**FINAL
ENVIRONMENTAL STATEMENT**

**MAINTENANCE DREDGING
GULF INTRACOASTAL
WATERWAY
TEXAS SECTION**

**PREPARED BY
U. S. ARMY CORPS OF ENGINEERS
GALVESTON DISTRICT**

OCTOBER, 1975

GULF INTRACOASTAL WATERWAY AND TRIBUT., TEXAS
MAINTENANCE DREDGING
 TRIBUTARY CHANNEL
 TO PORT MANSFIELD
 U.S. ARMY ENGINEER DISTRICT GALVESTON, TEXAS
 OCTOBER 1974 SHEET 1 OF 1

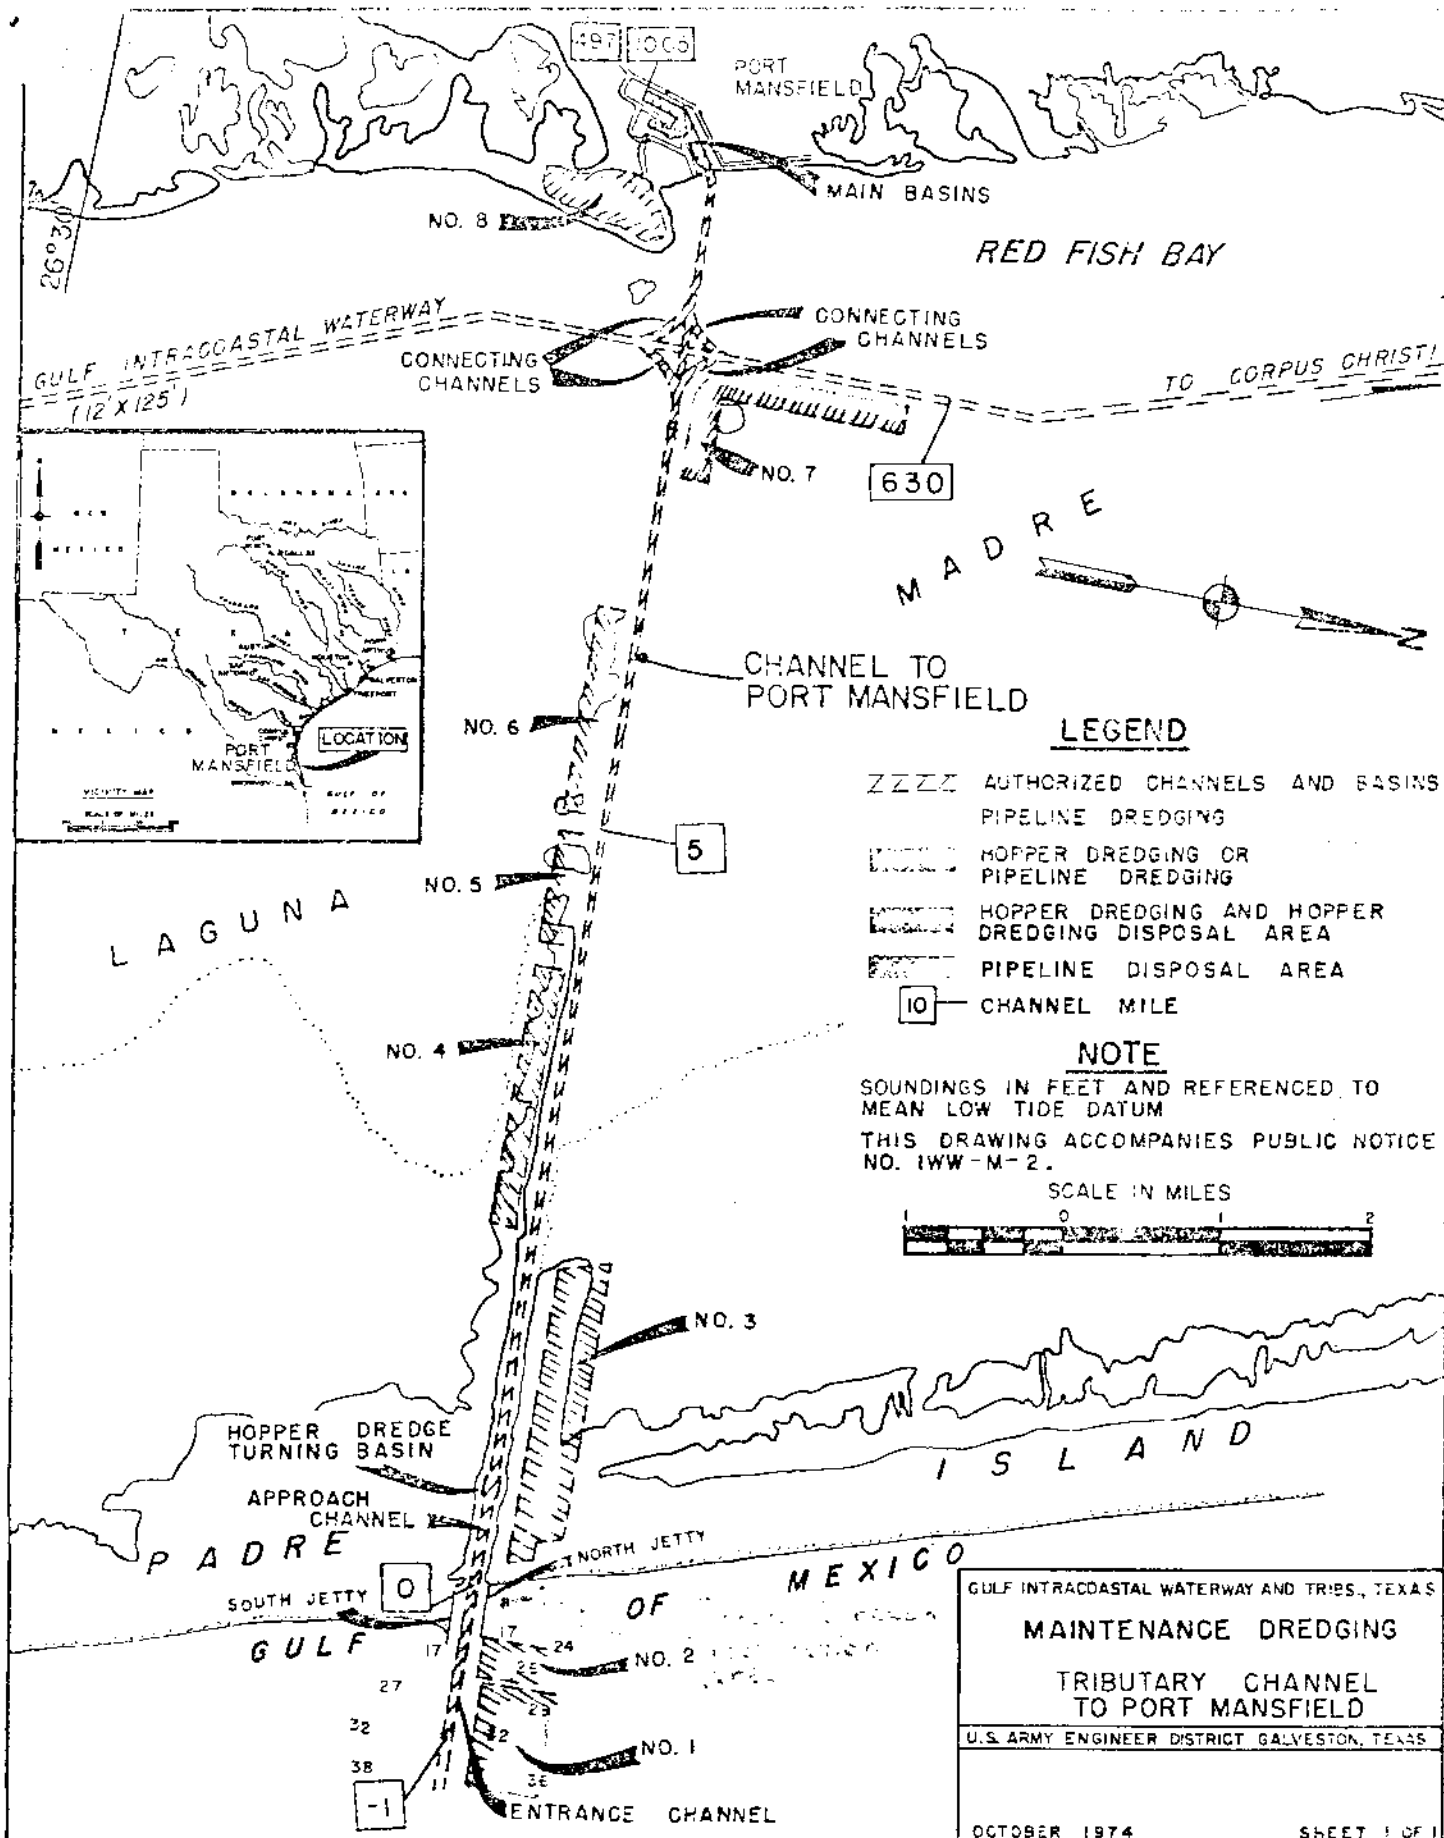
We normally maintain the entrance channel and jetty channel by hopper dredge and deposit the material in an open Gulf disposal area. The channels are presently shoaled to such an extent we can not use a hopper dredge, but must use a pipeline dredge. The material to be excavated will consist primarily of a sandy material. About 300,000 cubic yards of this material will be removed under the proposed contract.

We are aware of the extensive erosion that has taken place along the beach just north of the north jetty and propose to use the dredged material to refurbish and restore this beach area. This will be somewhat experimental and we hope the experience gained will give us insight for future projects of this nature. The approximate location of the proposed area to be used is depicted on the attached drawing.

We would appreciate your comments on this proposal. We are anticipating doing the dredging in May or June 1975. Should you have any questions concerning the proposed dredging, call Mr. George Rothen, 713 763-1211, extension 315.
